Dear Planning Board,

We are writing to you with some comments regarding the proposed Wireless Communications Facility for the property located at 5 Craig Rd. We would like you to consider each of the points mentioned below carefully when you decide whether or not to grant this Special Permit request. Our hope is that you will find that per the Acton By-Laws, you are unable to grant the Special Permit because of your duty to protect our residential neighborhood from adverse impacts of the proposed cell tower.

1/23/10 View from Rt. 2 of Balloon test for 5 Craig Rd.

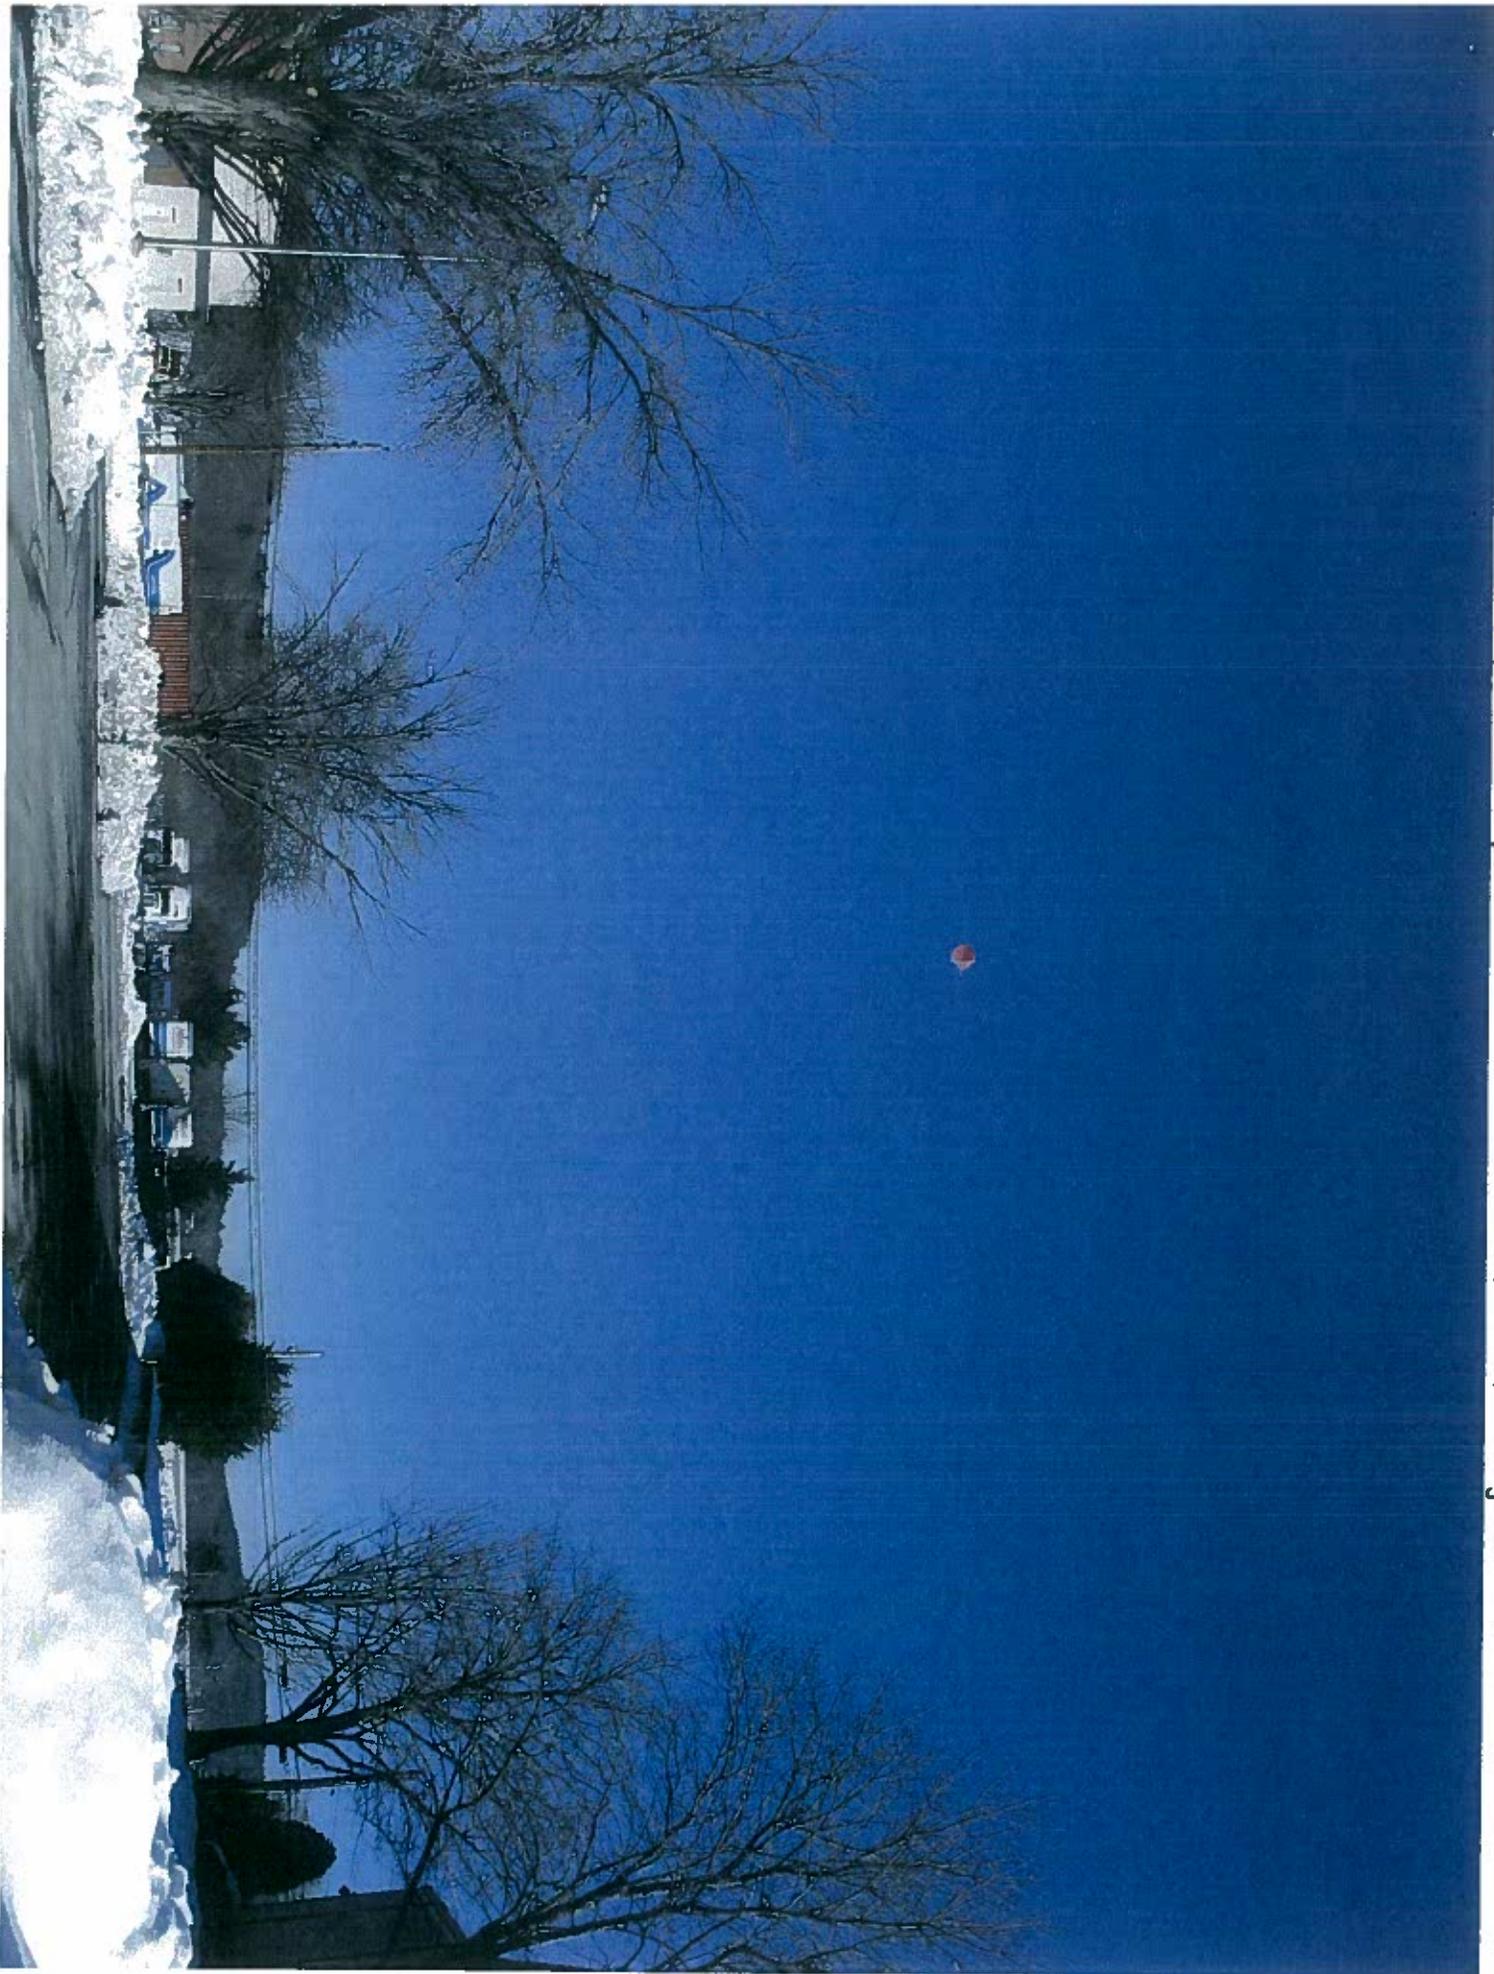
- 5.) Twenty-four Eastern Red Cedar with a maturity height of 25 feet are to be used as landscaping screen according to the applicant. How, specifically, will that block the visibility of a 170 foot tower? Per the pictures I am submitting, you can see that we and our neighbors will have clear views of the tower that two dozen trees that are 1/7 of the tower's height are not going to be able to mitigate. Also, if Rt. 2 is a National Scenic Byway, is an unscreened cell tower, not even a CAM if you grant their waiver, permitted, desired, or legal?

- 16.) The majority of my neighbors had no notice of the balloon test. This test should have been mentioned in The Beacon so that residents could view the test, which was only conducted for 4 hours. The test itself was very poor because the day was very windy and the balloon swayed back and forth by 50 feet or more. If the Planning Board wanted to properly evaluate what a 170' pole would truly look like at that site, they should have a crane come to the site for a second test. This would provide a more accurate evaluation of what the final tower might look like.

1/23/10 Balloon test, 5 Craig Rd. note trucks, dumpsters, weigh station, wetlands.

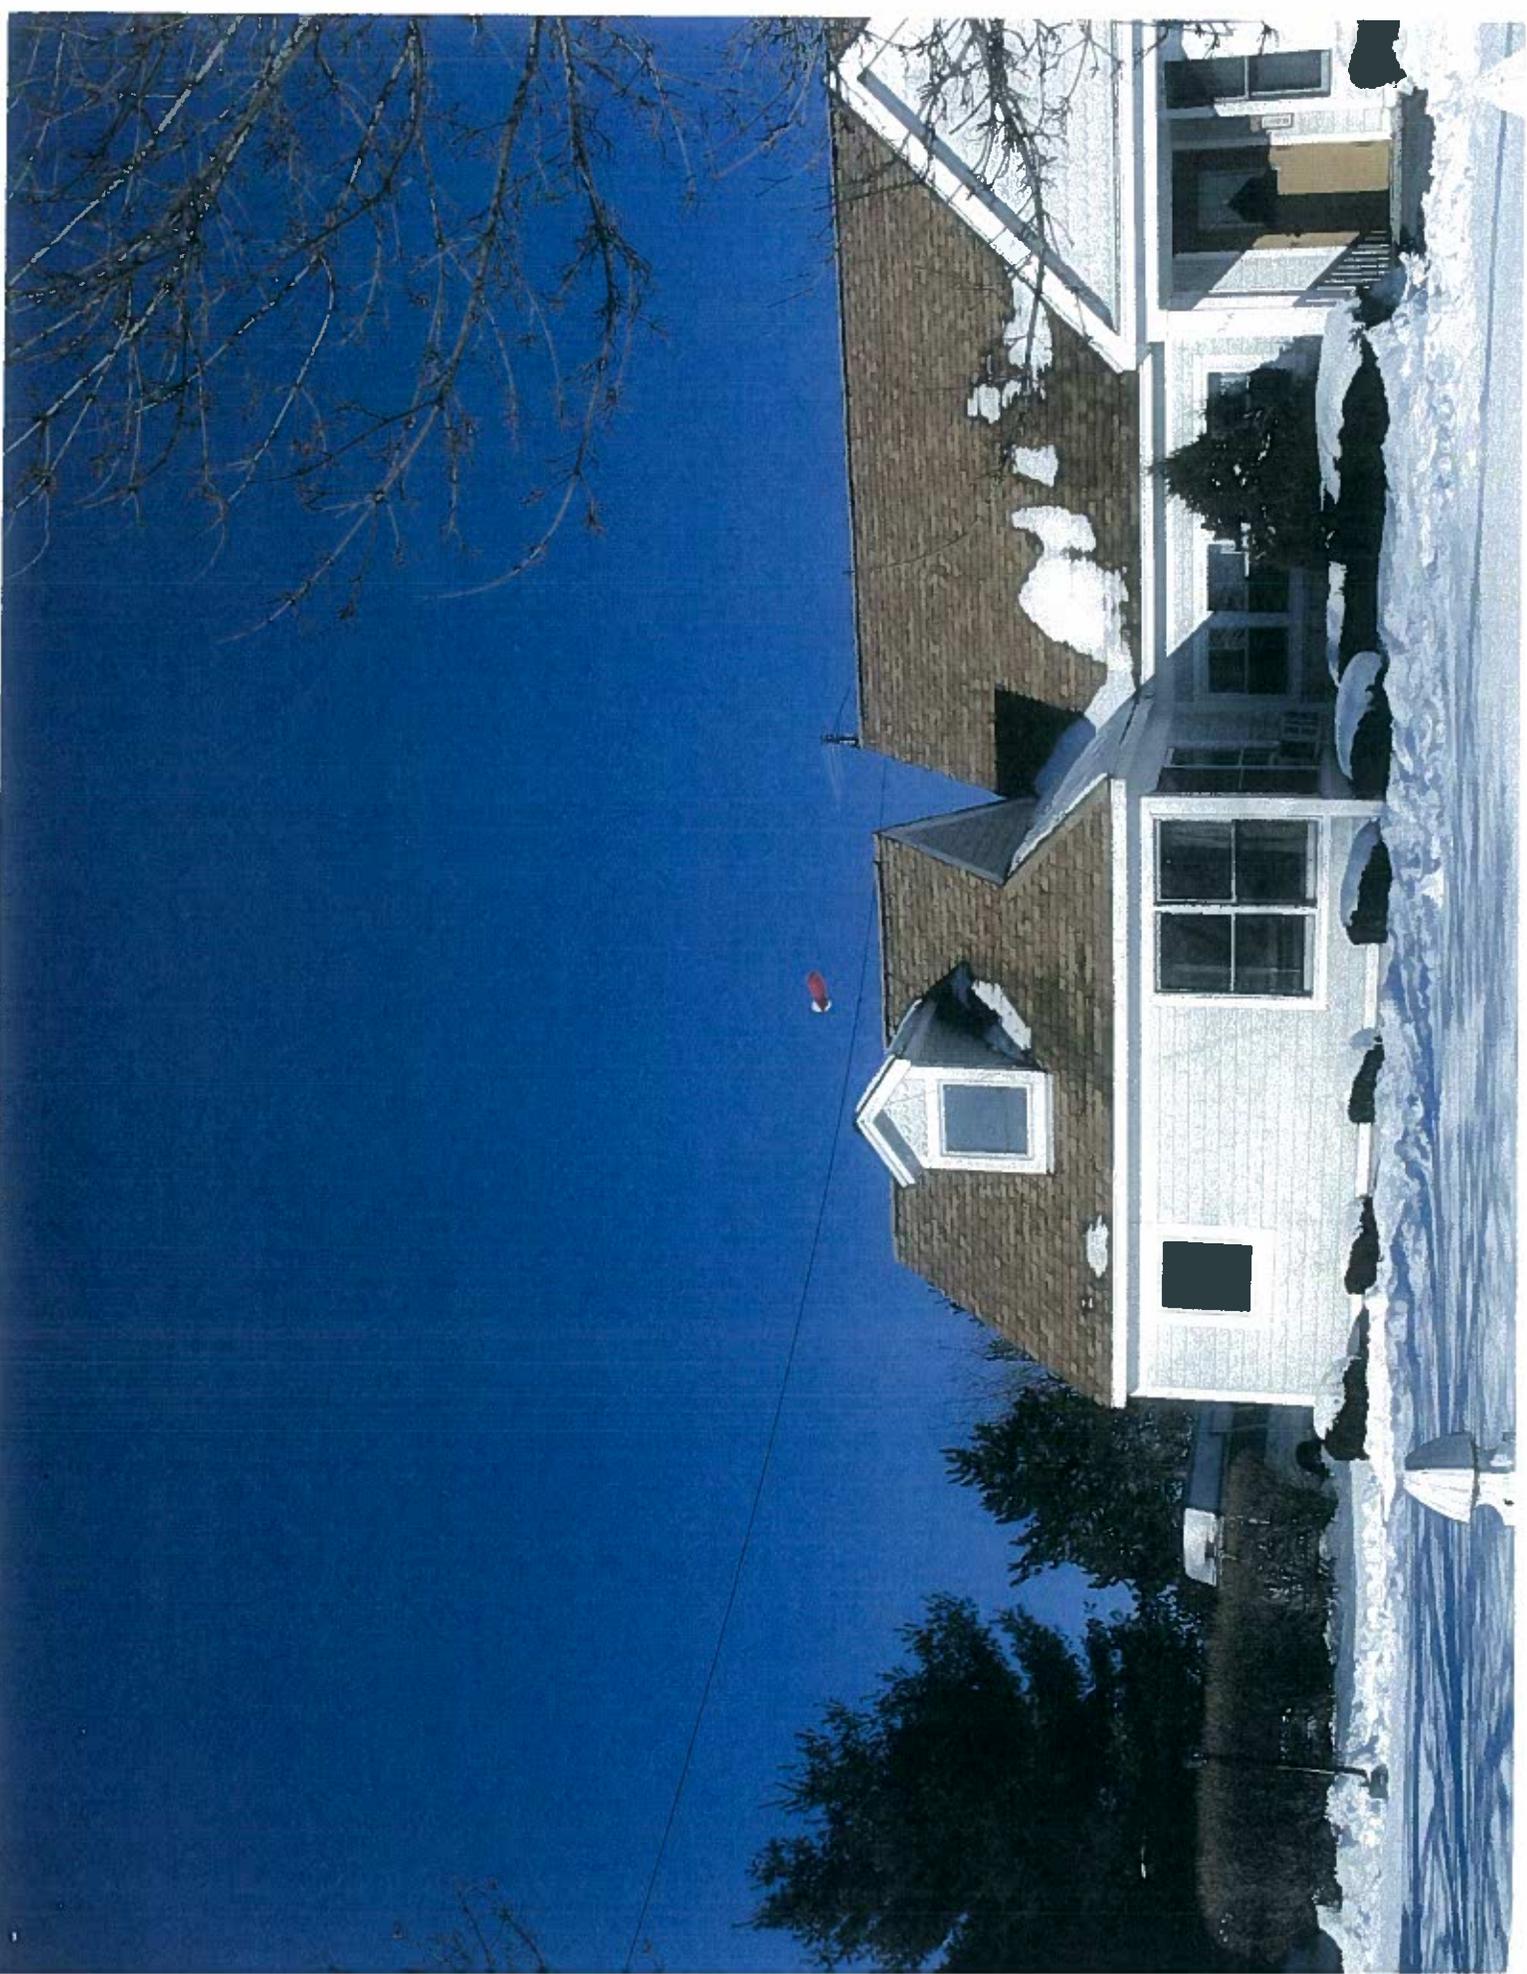
- 3.) This property is located next to John Palmer Moving and Storage. It is the current parking lot for the John Palmer moving trucks. Today there were 16 moving trucks, two dumpsters, and a truck weigh station occupying the parcel of land referred to as 5 Craig Rd. Recently the town of Acton also OK'd a Special Permit for this same location to have five rental trucks on the property. Our question to you is this, if the Planning Board OK's the proposed Wireless Communications Facility, and it is built to specifications and landscaping and equipment buildings are added, as suggested in SBA's plans, where will the 16 moving trucks, two dumpsters, the truck weigh station and the five rental trucks be located? The specifics of the other Special Permit should be reviewed since 5 Craig Rd. cannot physically hold all of the above mentioned.

- 4.) Also, we remember that the town denied John Palmer the ability to build in the 1990's because of the property's proximity to wetlands (please see enclosed photo). Those wetland conditions have not changed since that ruling and building that close to wetlands is certainly regulated and must be addressed as part of this Special Permit.

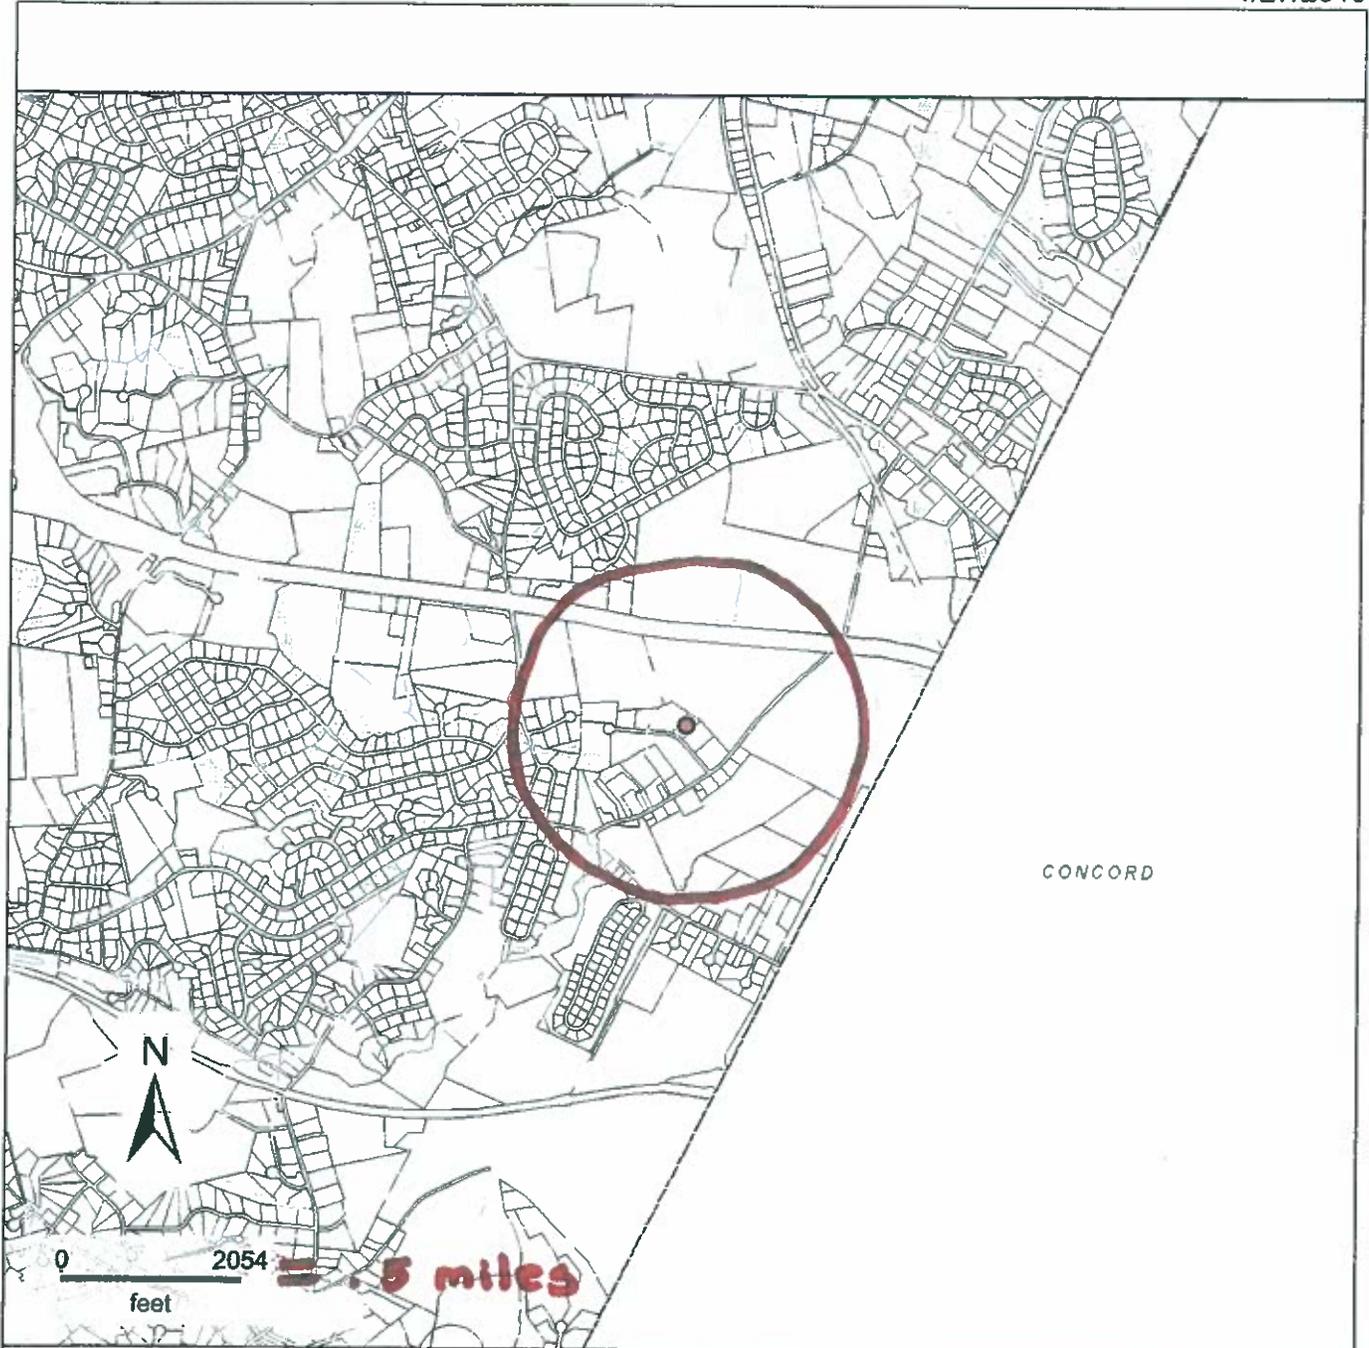
The Affidavit of Site Acquisition Specialist John-Markus Pinard states that, “(i)n this instance, the illustrated area is located in the residential areas of Acton and has approximately .5 mile radius contingent on terrain and tree coverage in a given location.” Craig Rd. sits low in a valley or bowl that will prevent a cell tower’s signal from reaching even up to a half mile. The largely forested area will also keep this tower from providing much of a signal. And then if one is to look at our neighborhood, there are few residences in that .5 mile radius. The majority of land behind the proposed monopole tower (looking at it from Craig Rd.) is farm land, water department land, soccer fields, forest, prison land, auto auction and Acton Town dump, none of which will ever be developed or need “In Building Coverage” as alleged by T-Mobil. T-Mobil already acknowledges sufficient automobile coverage, so despite the close proximity to Rt. 2, that should not be a factor because they are not deficient in that area. Also, Mr. Pinard states that he found our neighborhood to be “largely residential”. If this is so, then why is SBA Tower II, LLC asking for a waiver of Acton By-Law Section 3.10.6.4 when their own specialist recognizes how close this tower would be to residential homes?

Note primarily open space in area that the applicant's carriers are trying to increase "In-Building" coverage.
